PRB RESULTS: REPLY

REQUESTED BY: AJV-A PRB RESULTS: RETURN FOR REWORK MISSING DOCUMENTATION:

FIPC BASIC FORM						
PROCEDURE: LDA -G AMDT 2A			AIRPORT NAME: VALDEZ PIONEER FLD		AIRPORT ID: PAVD	SPECIAL CONTROL NO: KP-04-224-23
FAC ID: VDZ		CITY: VALDEZ			ST: AK	ORIG CHART DATE: 08/10/2023
DFL TYPE: PROC/A	THIRD PARTY: <input type="checkbox"/> YES	EST. TIME ON SITE: 0.4	REIMB. NUMBER:	PTS TASK ID: 3B09276E70954C11B62CC9264D77E9D6		
PREFLIGHT NOTES						
REVIEWER: dustin d hanson					DATE: 05/19/2023	
COMMENTS:					CHECK ONE:	
					<input checked="" type="checkbox"/> FLT CK REQ <input type="checkbox"/> NFCR <input type="checkbox"/> REJECT	
						YES
					CPV COMPLETE?	
					X	
PROCEDURE RESULTS						
INSPECTION DATE: 05/19/2023	CREW #: VN471	N #: N85	INSTRUMENT PROCEDURE STATUS: <input checked="" type="checkbox"/> SAT <input type="checkbox"/> SAT W/CHANGES <input type="checkbox"/> UNSAT		ARINC CODING: <input type="checkbox"/> SAT <input type="checkbox"/> SAT/GOLD <input type="checkbox"/> UNSAT

LDA-G
VALDEZ PIONEER FIELD (VDZ) (PAVD)

FIG

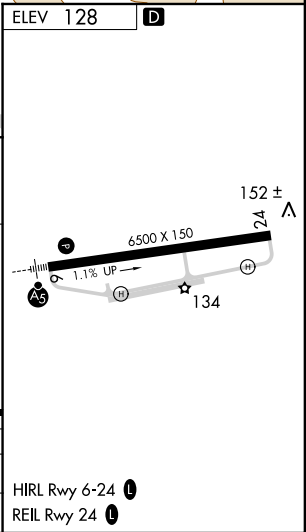
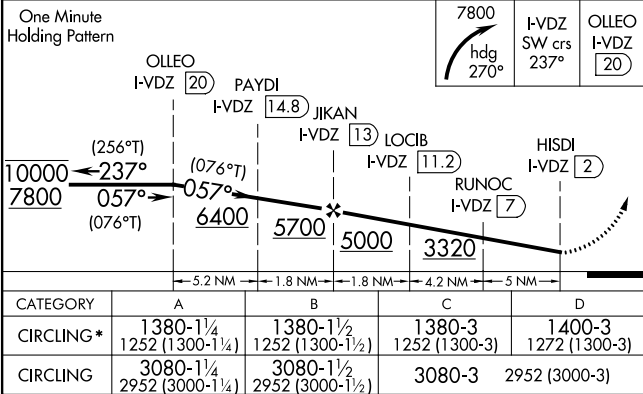
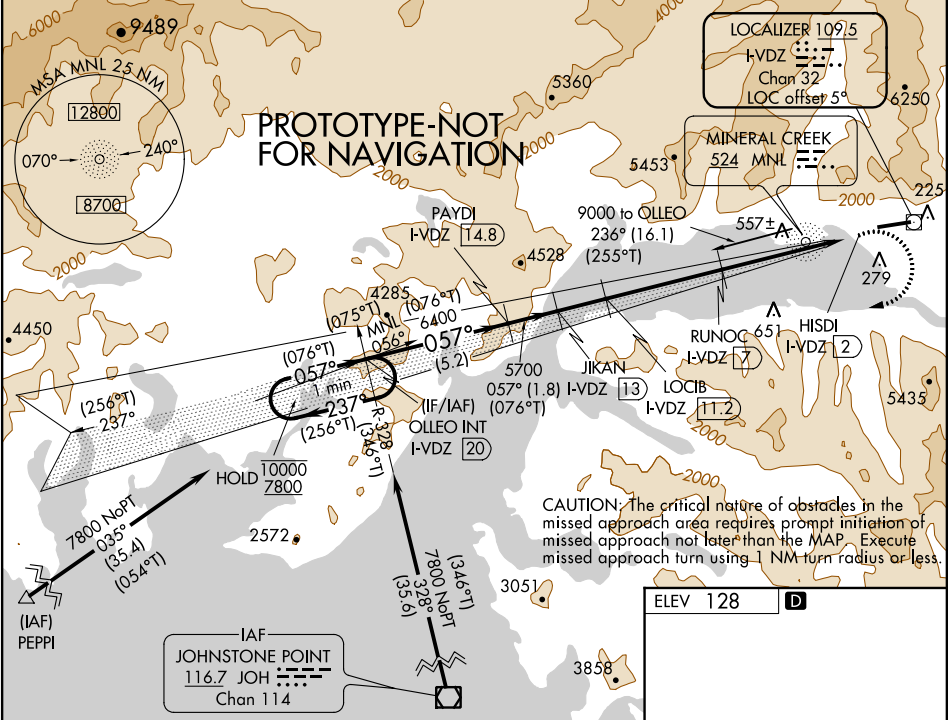
- FIG: PEPPI (IAF) IS DEPICTED ON THE FIG AS A FIX RATHER THAN A WAYPOINT. IT IS NOTED ON THE 8260-7A AND THE 8260-2 IN THE PACKAGE AS A WAYPOINT
 - PEPPI 8260-2 UPDATED TO REMOVE FAC 1 FROM THE LDA-G PROCEDURE.

- THE INITIAL SUBMISSION DEPICTING PEPPI AS A FIX IS CORRECT. THE SEGMENT FROM PEPPI IS RNP APCH-GPS SO PEPPI IS USED AS A WP.
 - PER CHARTING, PEPPI IS NOT CHARTED AS A FIX ON PURPOSE. IT IS USED BY V319 AND ON THE ENROUTE LOW CHART IT IS REQUIRED BY CHARTING TO BE SHOWN AS FIX EVEN THOUGH IT IS USED AS A WAYPOINT ON THE PROCEDURE.
